SUBJECT: STAFF OBSERVATIONS FROM JANUARY 2008 TRIP TO THE PCI/ALDEN TEST FACILITY TO OBSERVE HEAD LOSS TESTING FOR WOLF CREEK AND CALLAWAY PLANTS

OBSERVATIONS OF TESTING AT ALDEN RESEARCH LABORATORY
JANUARY 16 TO JANUARY 18, 2008

Figure 1. Evidence of Thin-Bed Debris Accumulation

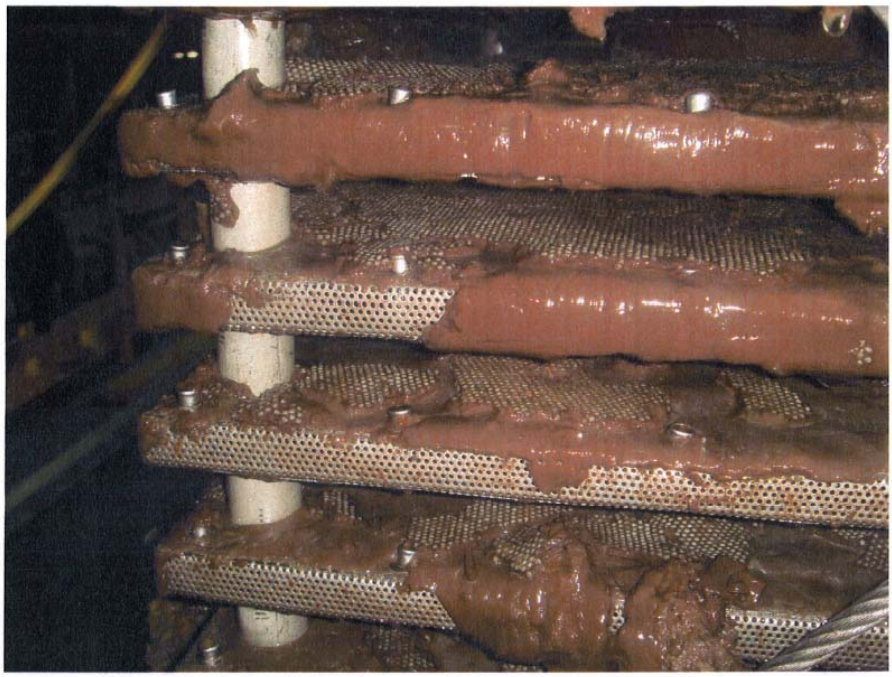
Figure 1 shows evidence that a thin bed accumulation formed. In this photo, small sections of accumulation at the edges of the disks look like a classic thin bed formation. At others location, such as on the bottom disk in the photo, globs of scooped up thin bed debris can be seen. It is unrealistic to assume a thin bed can form at selected locations, such as at disk edges, and have no debris accumulate on other screen surfaces. The reasonable conclusion was that a thin bed formed on all strainer surfaces but was subsequently highly disrupted at test termination which effectively cleared substantial screen surface of debris. A head loss calculation using the NUREG/CR-6224 correlation demonstrates that a thin bed consisting of the walnut flour and the chemical precipitates could cause the observed head losses. In this calculation, the full load of walnut flour and the chemical precipitates was assumed to accumulate in the debris bed and that the specific surface area of the chemical precipitates was on par with that of calcium silicate. The correlation indicated that the walnut flour alone could not cause such a high head loss.
